Product Change Notification / GBNG-14DIAU526

CCB 4821 Final Notice: Qualification of ATP7 as an additional assembly site for selected AT90CAN64 and AT90CAN128 device families available in 64L VQFN (9x9x0.9mm) package.

**CCB 4821**  
**Pre and Post Change Summary**  
**PCN# GBNG-14DIAU526**

NSEB

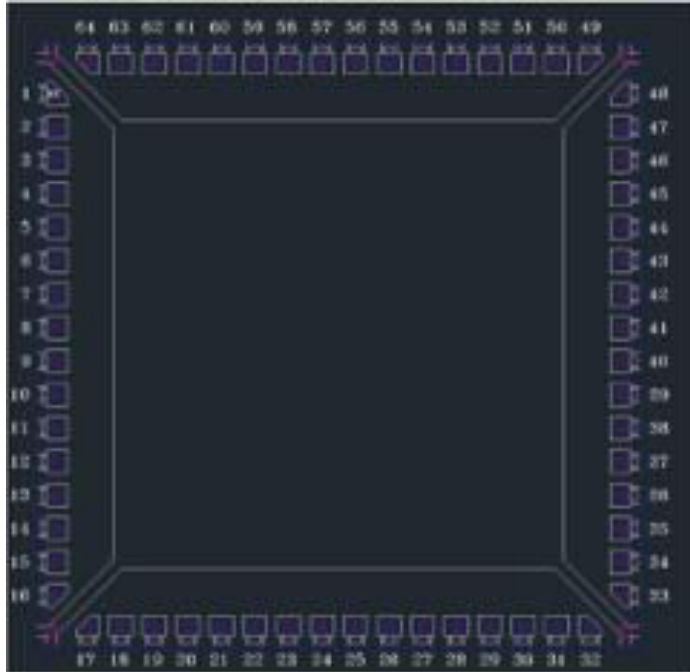
DAP Surface Prep	Ag on lead only
Paddle size	264x264 mils

ATP7

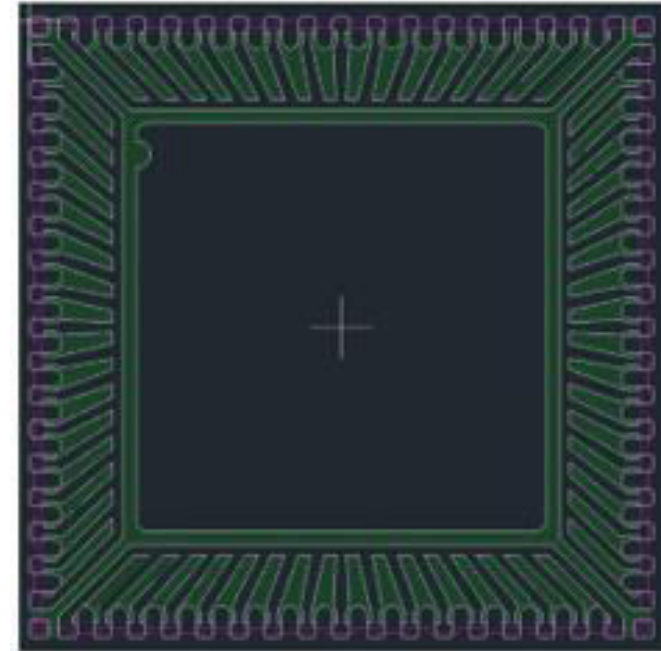
DAP Surface Prep	Ring Plating
Paddle size	252x252 mils
